V2500-A5/D5 SERIES PROPULSION SYSTEMS SERVICE BULLETIN

This document transmits Revision 4 to Service Bulletin V2500-72-0534 and Revision 4 to the Supplement

V2500-ENG-72-0534

ENGINE – PROVIDE NEW SECOND STAGE TURBINE AIR SEAL**1. Planning Information****A. Effectivity****(1) Airbus A319**

LOCATION OF THE STAGE 2 HIGH PRESSURE TURBINE AIR SEALS
Figure 1

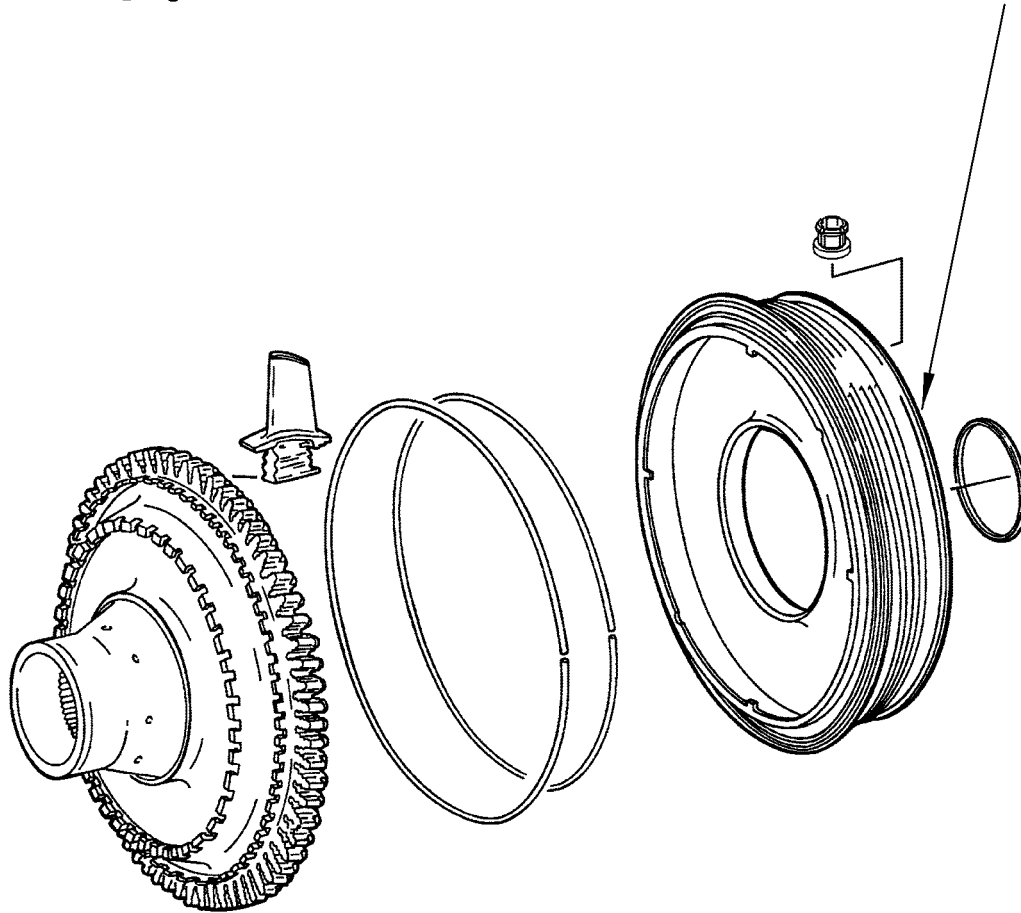
INSTALL THE 2A4157
STAGE 2 HIGH PRESSURE
TURBINE AIR SEAL (1OFF)

FAMILY TREE - ROTOR AND STATOR ASSEMBLY REF. CATALOG SEQUENCE NO. 72-45-00 FIGURE
01 ITEM 001
CHART A (Sheet 1 of 9)

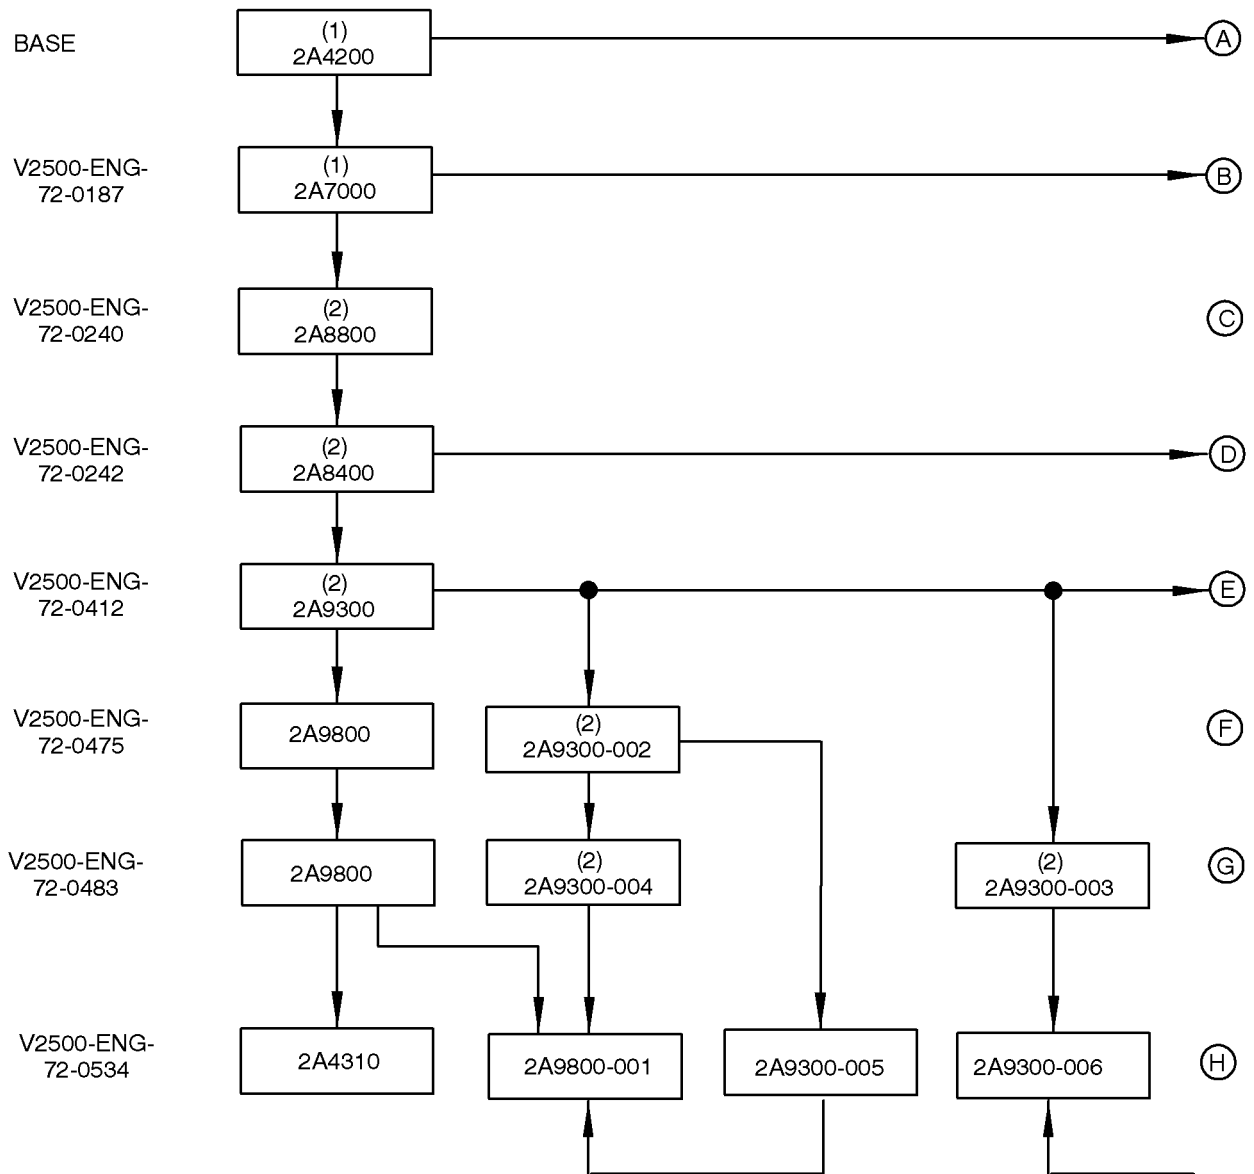
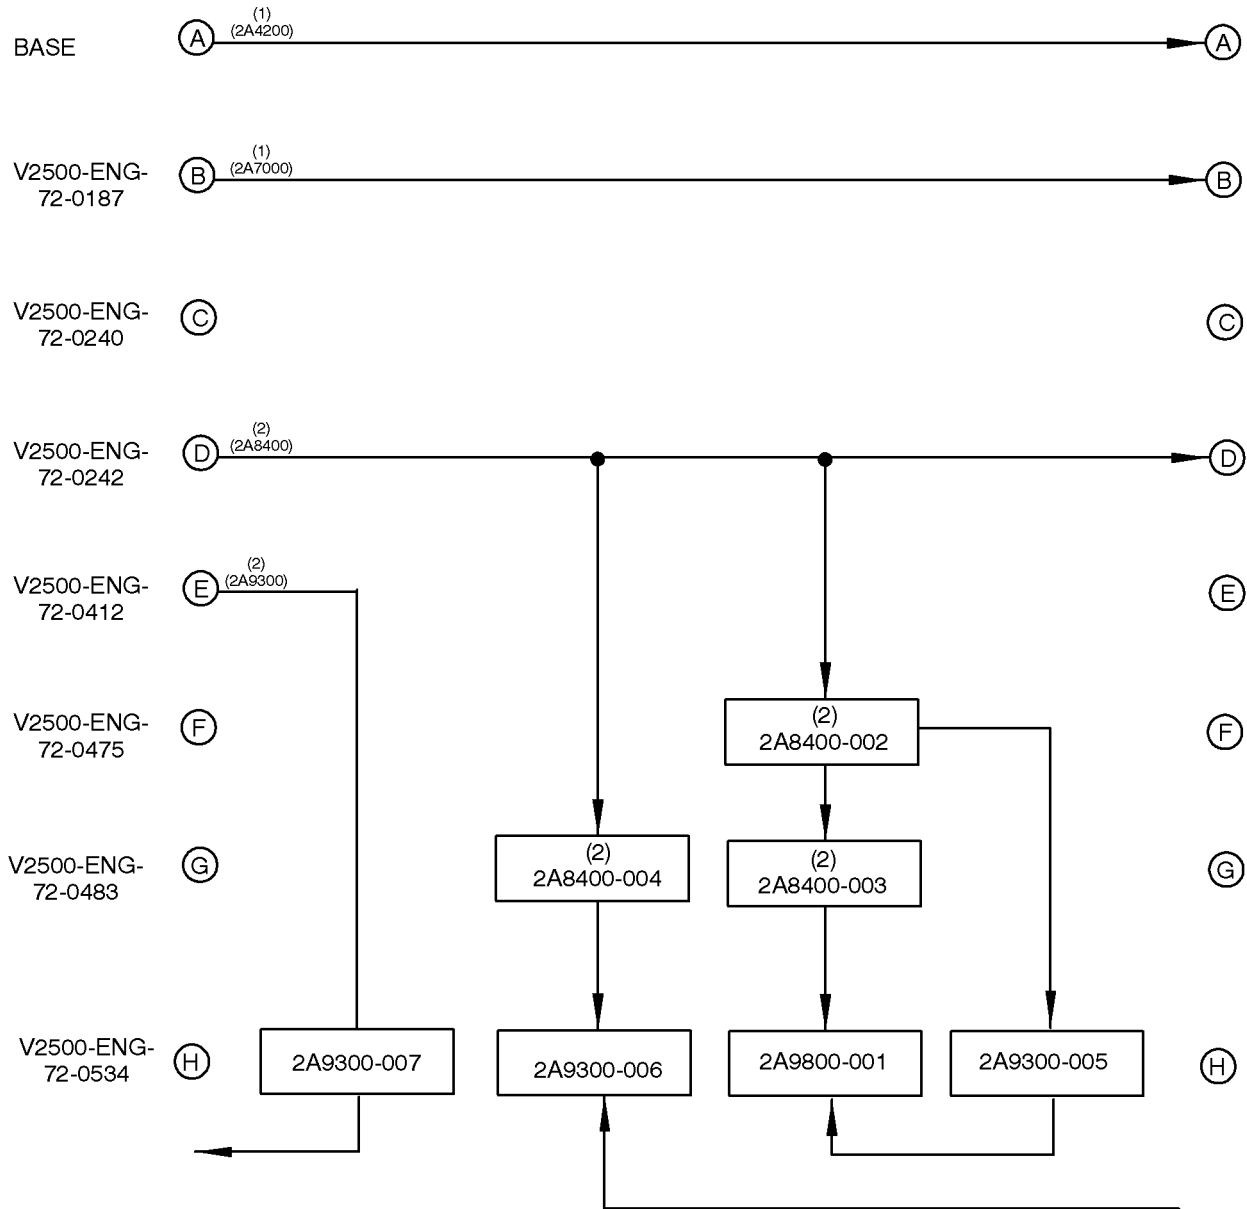
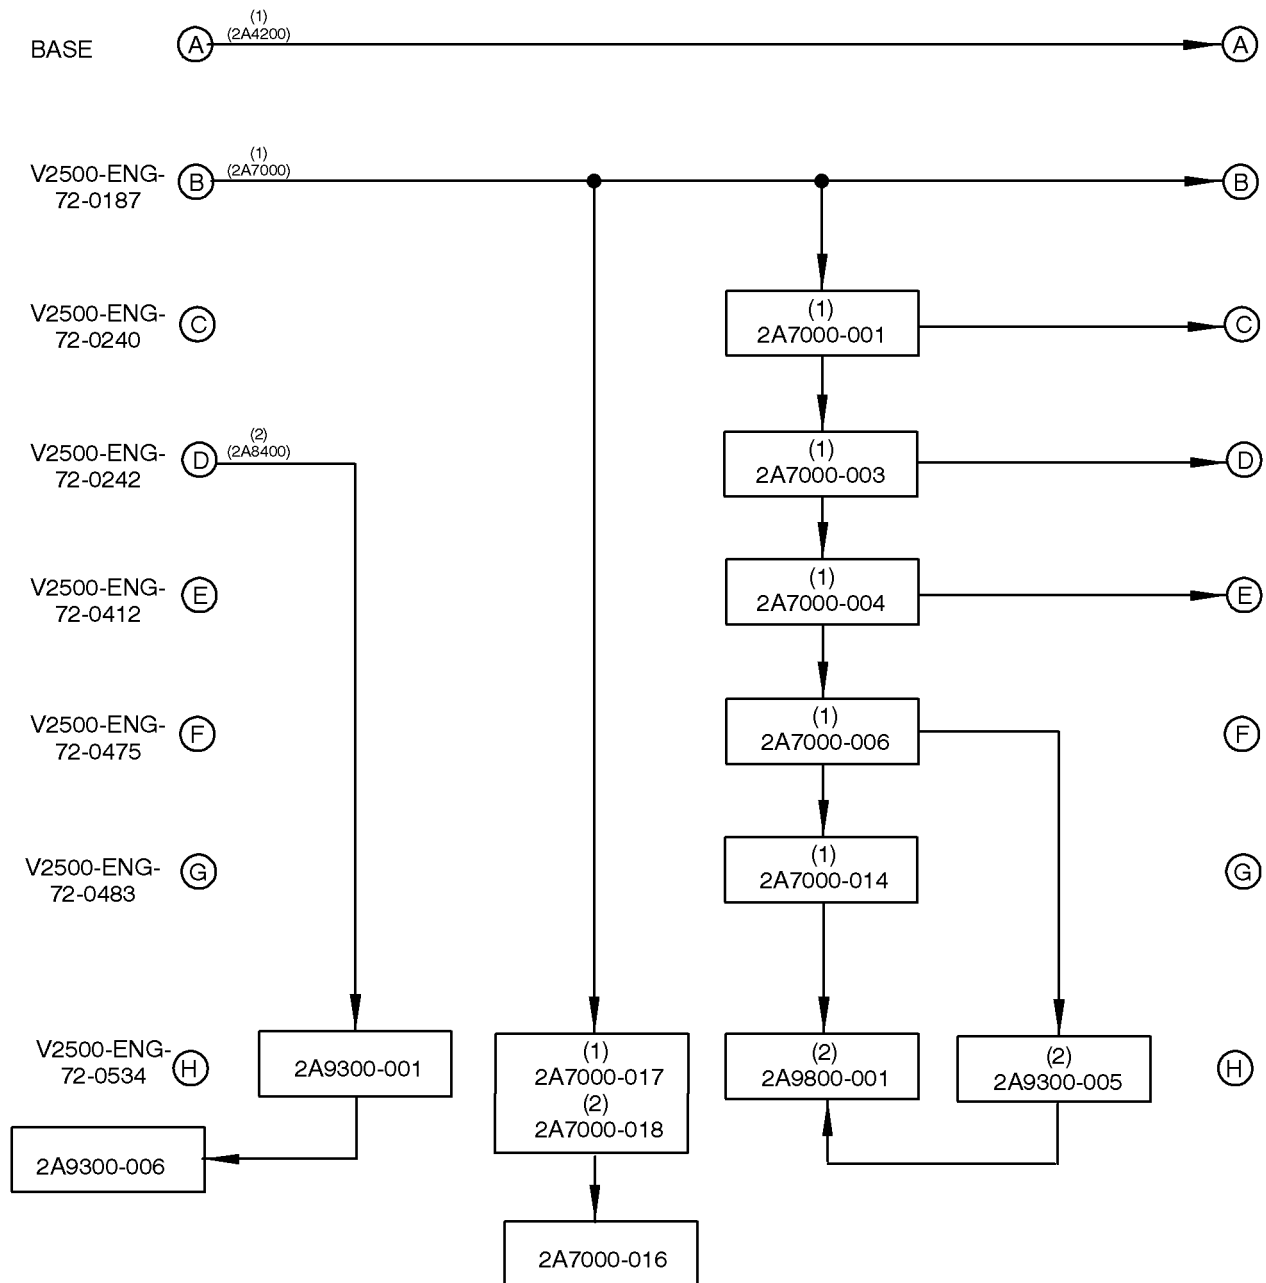
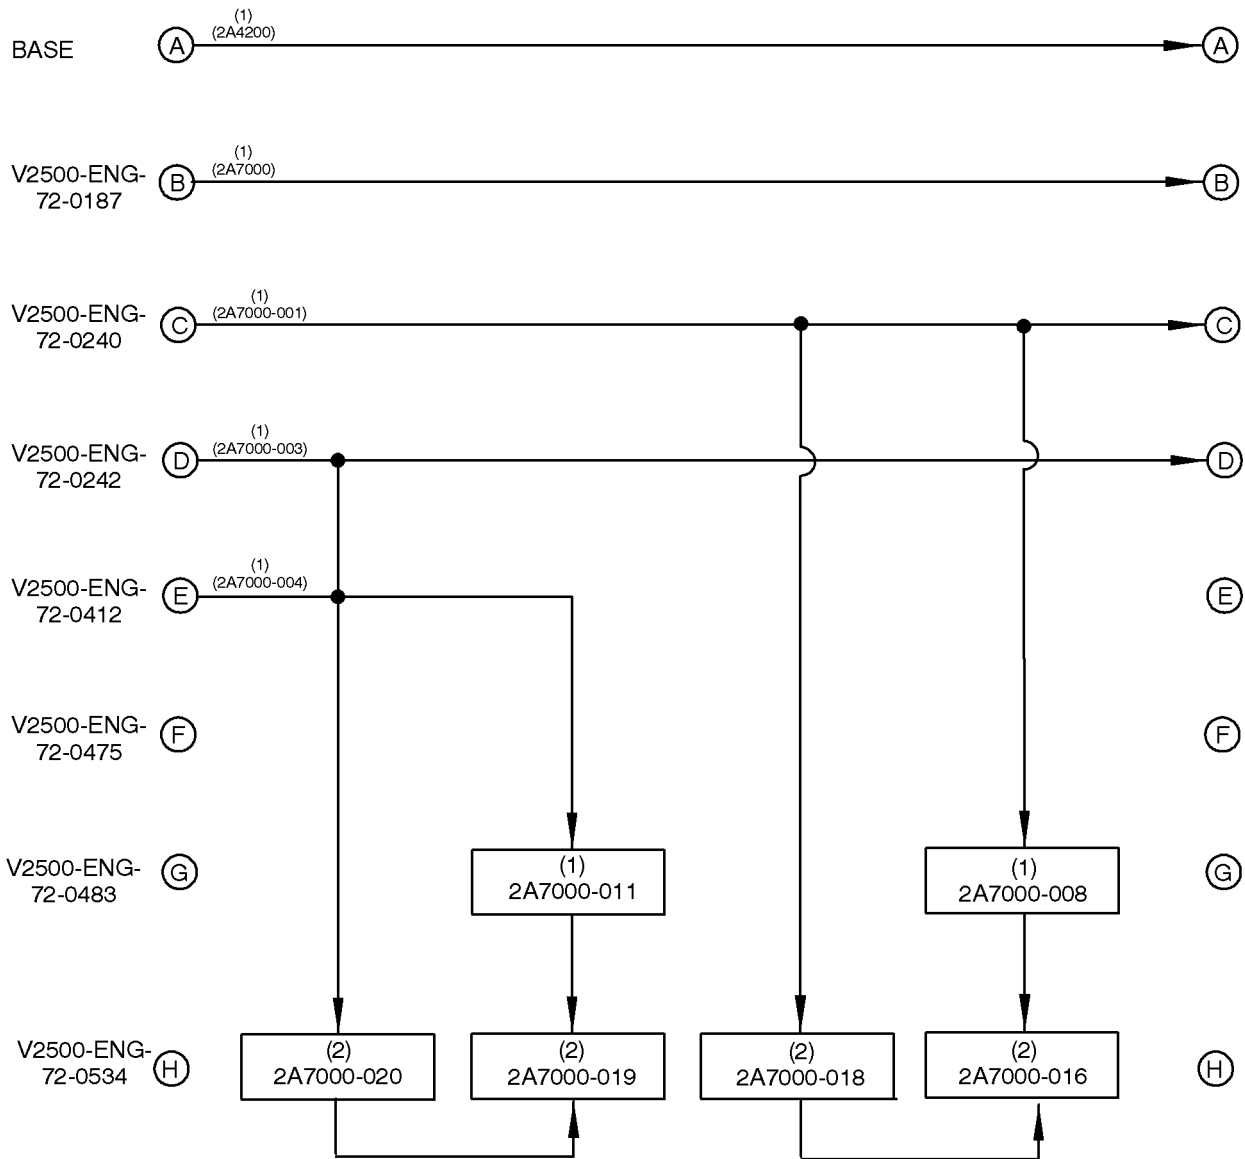
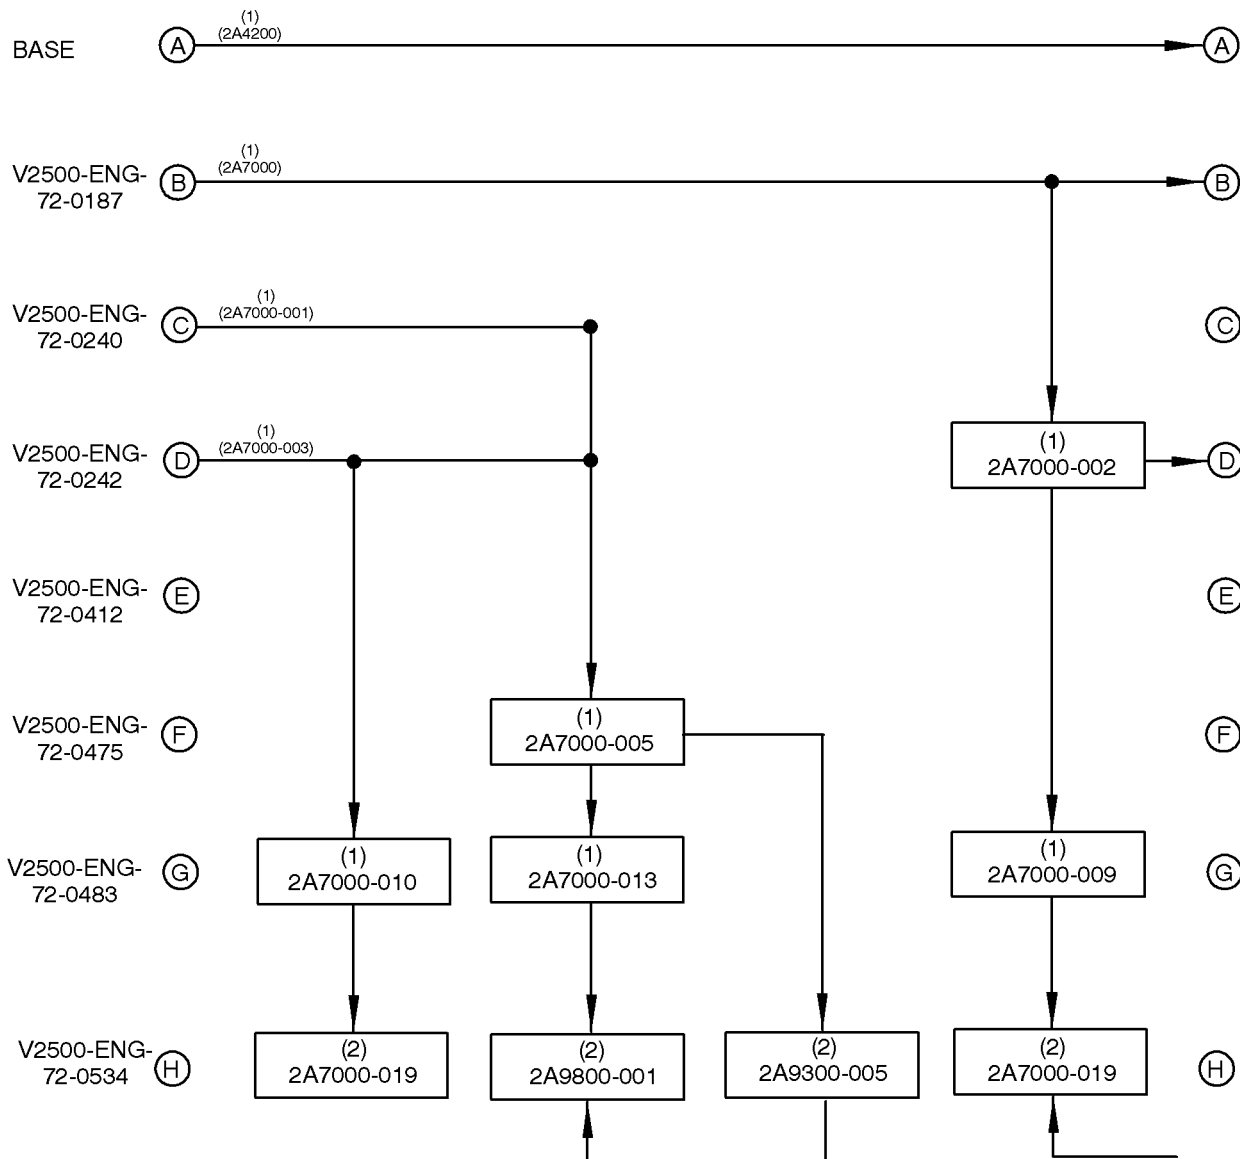
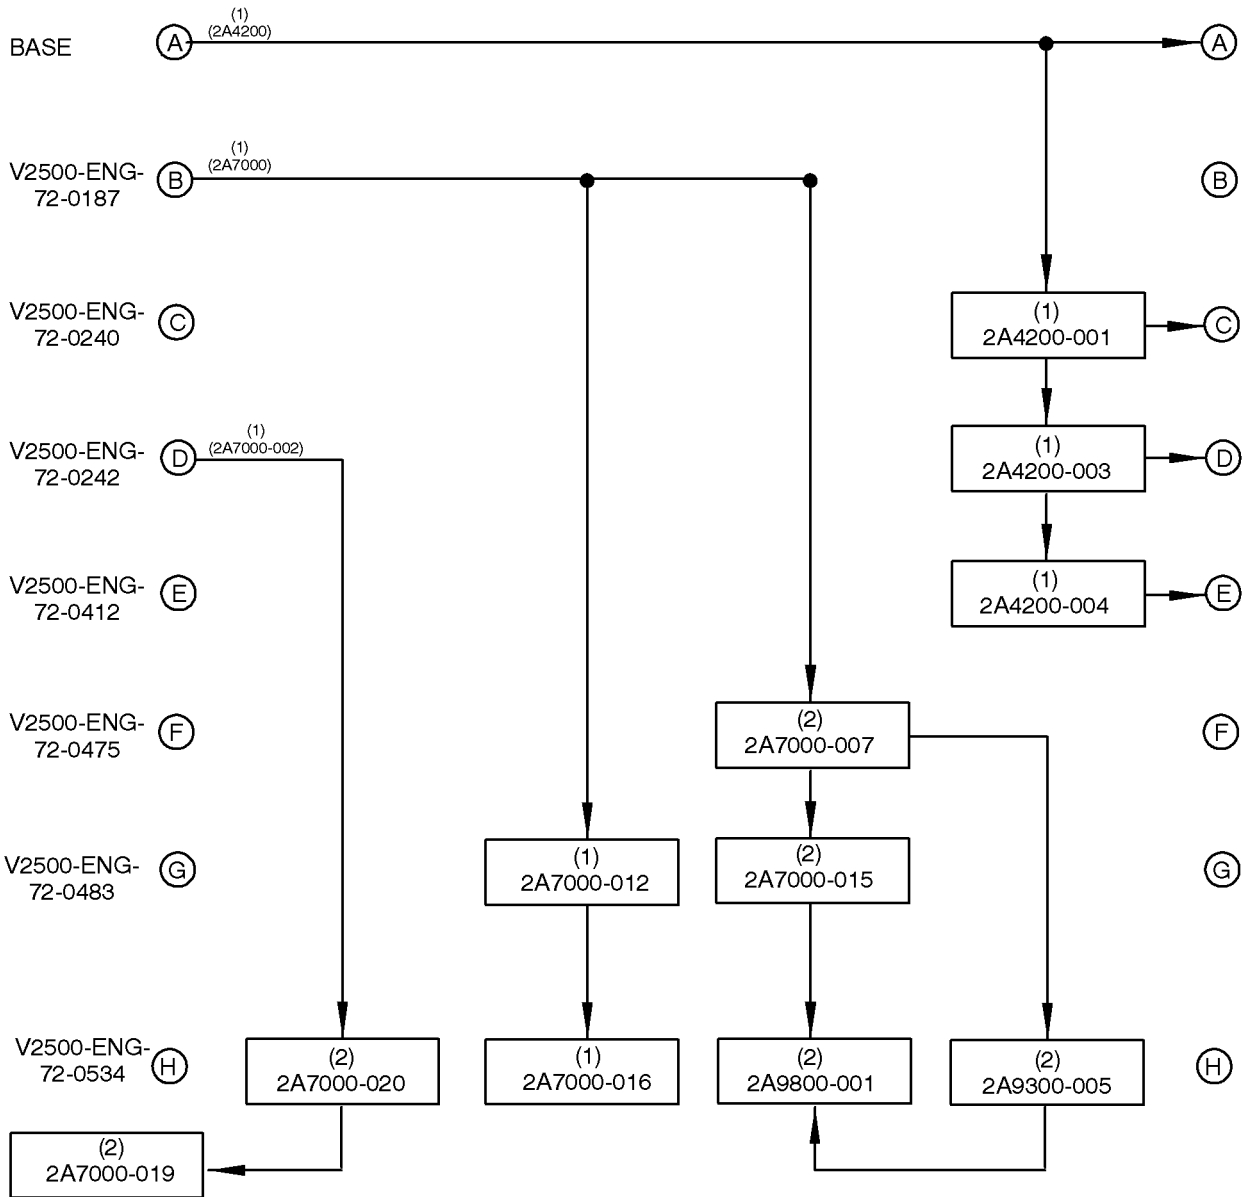
Remove	Incorporate	Reason for change
All pages of the Service Bulletin	Pages 1 to 29 of the Service Bulletin	To provide correct part numbers, which had been transposed, in the Interchangeability of Parts section.
All pages of the Supplement	Page 1 of the Supplement	None.

R The new seal, PN 2A4157 is only one-way interchangeable with the current seal,
R PN 2A3596. The new seal may be fitted in lieu of the old seal but not vice-versa.
